AN_8014BL_063   **January 2010**

Replacing the 73S8014R with the 73S8014BL

Figure 1: 73S8014R and 73S8014BL Dual Schematic

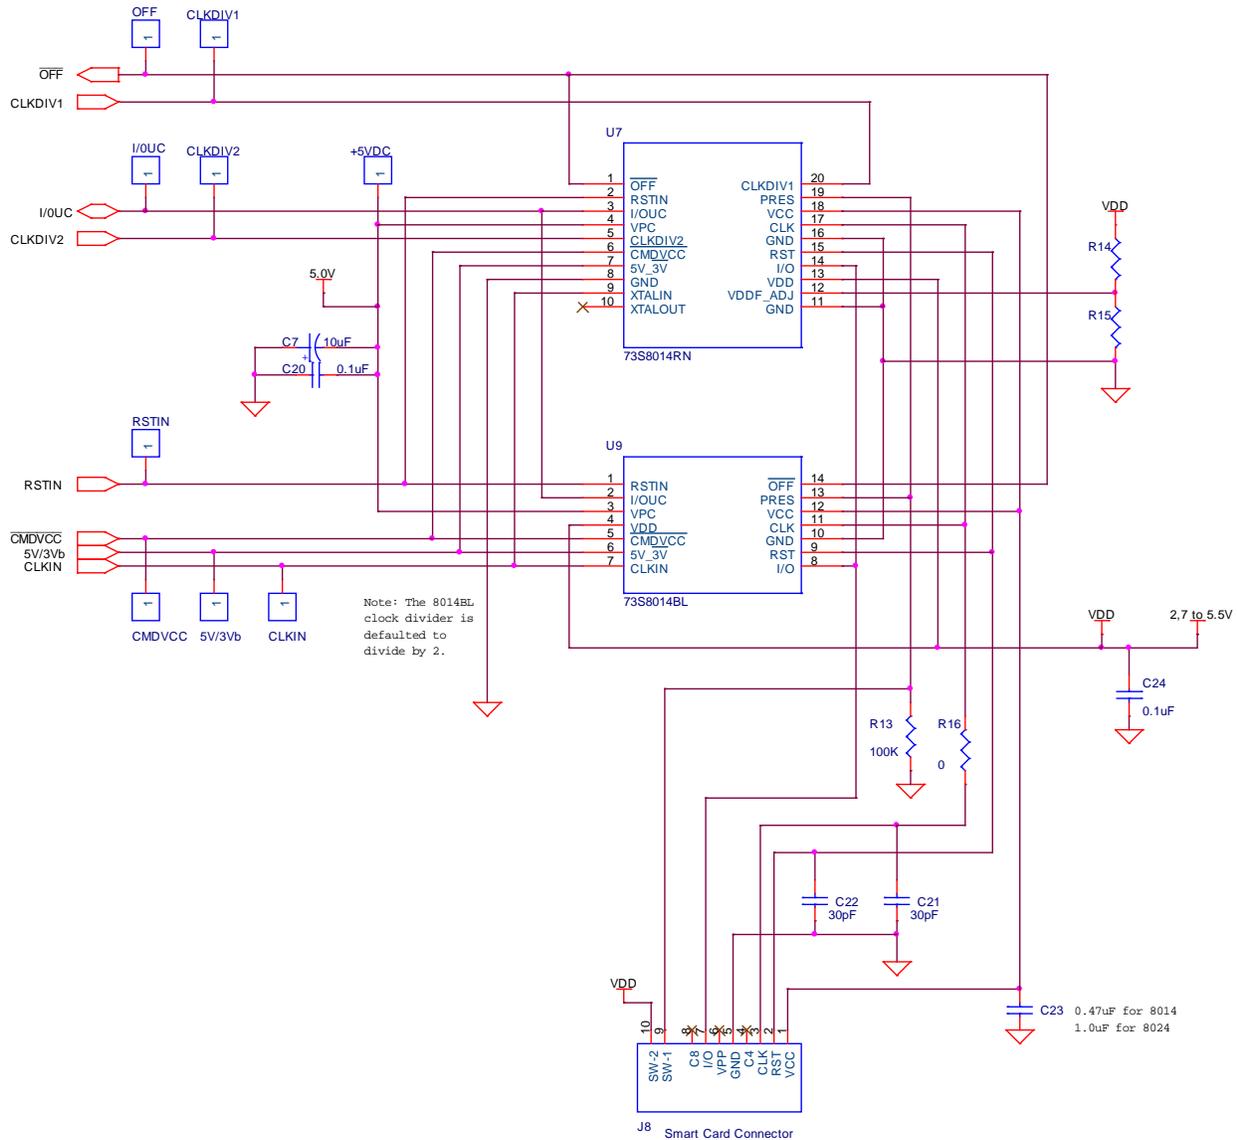
If having a dual footprint layout able to support both the 73S8014R and 73S8014BL is desired, then the schematic shown in Figure 1 will accomplish this. This schematic allows for either the 73S8014R or 73S8014BL device to be used in a given application to allow for the greatest flexibility in manufacturing. Using this schematic and adhering to the firmware precautions in Section 4 allow the full interchangeability of using either the 73S8014R or 73S8014BL.
